Customer	: CU-DAR001 Dart Helicopters Services	Drawing Name	: HELI UTILITY BASKET LH/RH 350/355
Job Number	: 32998		
Estimate Number	: 10208		
P.O. Number	: N/A	Part Number	: D350607043
This Issue	: 6/19/2007 S.O. No. : N/A	Drawing Number	: D350-607 REV F P7-9
Prsht Rev.	: NC	Project Number	: N/A
First Issue	: N/A Type : LARGE FAB ASSY	Drawing Revision	: F
Previous Run	: 32868	Material	: N/A
Written By	:	Due Date	: 7/2/2007
Checked & Approved By	: <u>07.06.20</u>	Qty:	1 Um: Each
Comment	: Est Rev:E as Per DSI9318 06-01-24 JLM

DESIGN <i>CP</i>	DRAWN BY <i>CP</i>	DART AEROSPACE LTD HAWKESBURY, ONTARIO, CANADA	
CHECKED <i>[Signature]</i>	APPROVED <i>[Signature]</i>	DRAWING NO. DSI 9318	REV. A SHEET 1 OF 1
DATE 06.01.06		TITLE WASHER ADDITION	SCALE NTS
A	06.01.06	NEW ISSUE

DART SERVICE INSTRUCTION

TO AMEND INSTALLATION INSTRUCTIONS D350-607 REV. F

Figure 5- Basket Replacement Parts
(D350-607-043 Heli-Utility-Basket™)

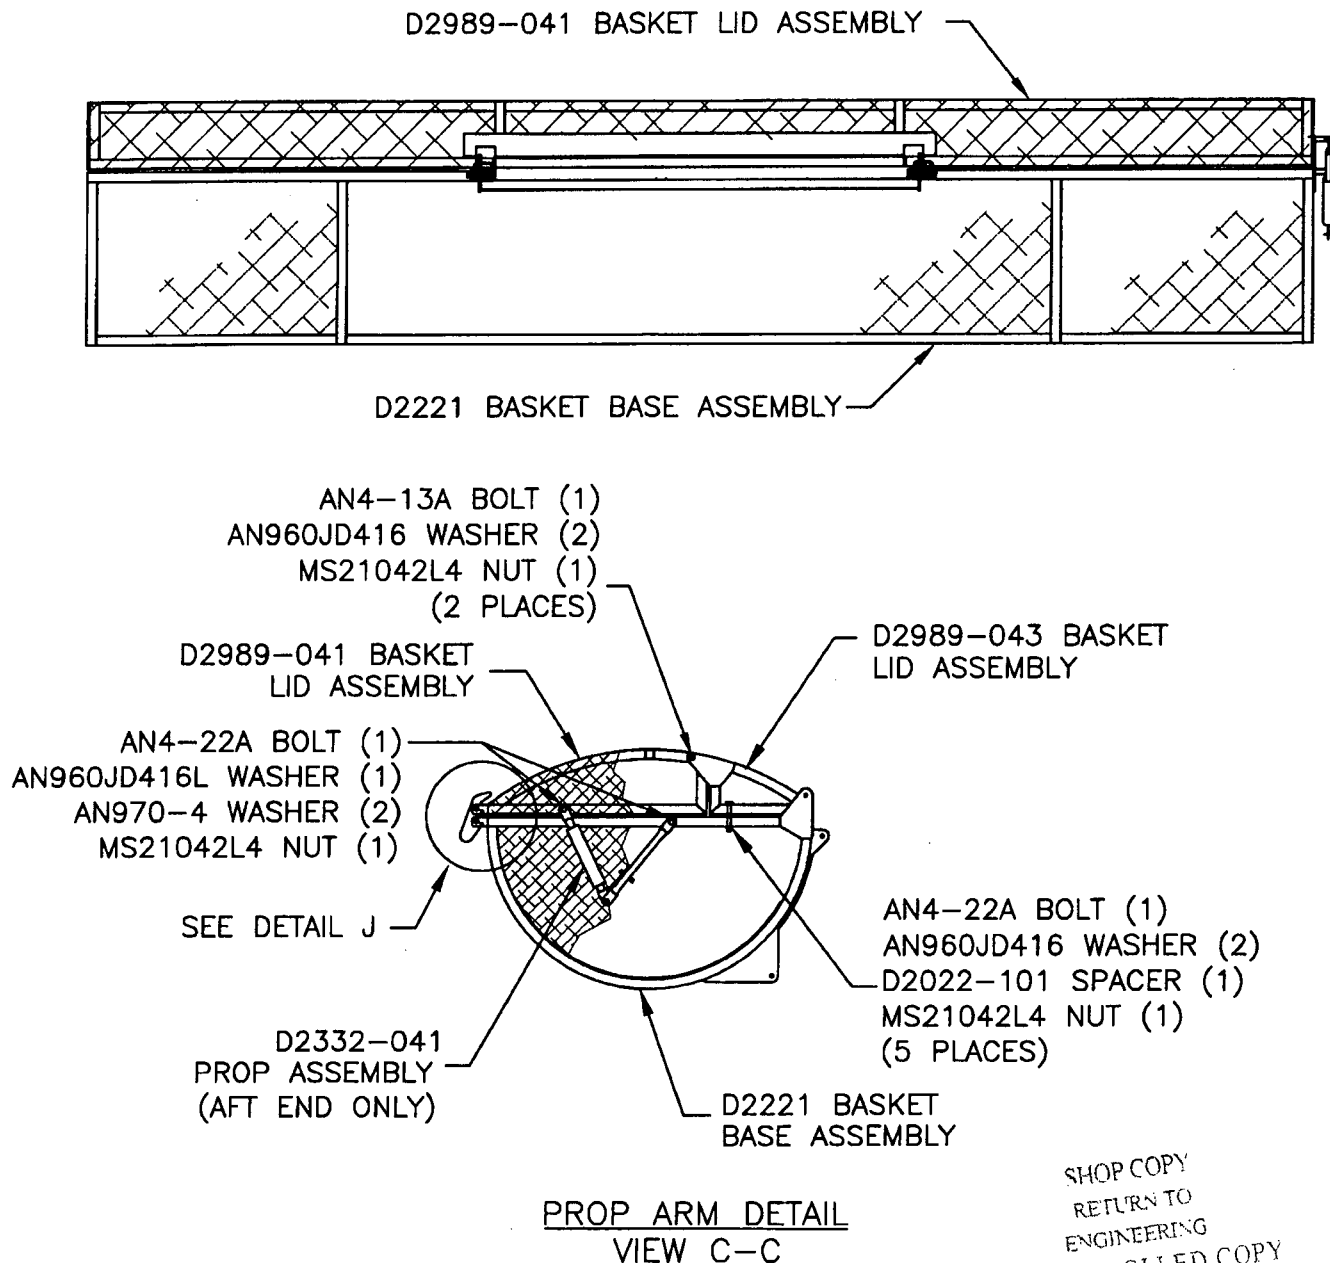
The corrected bolt stackup from Figure 5 of installation instructions D350-607 Rev. F is given below:

AN4-13A BOLT (1)
AN960JD416 WASHER (1)
HINGE PLATE (REF)
NAS1515H4 WASHER (1)
BASKET FRAME (REF)
AN960JD416 WASHER (1)
MS21042L4 NUT (1)
(2 PLACES)

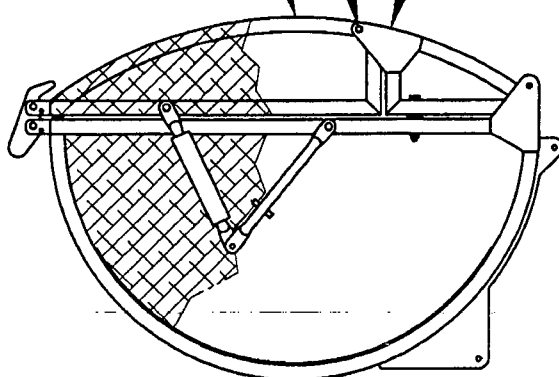
To reduce the possibility of damaging the finish, a **NAS1515H4** washer (2 places) has been added between the hinge plate and basket frame on the **D350-607-043/-047 Heli-Utility-Basket**.
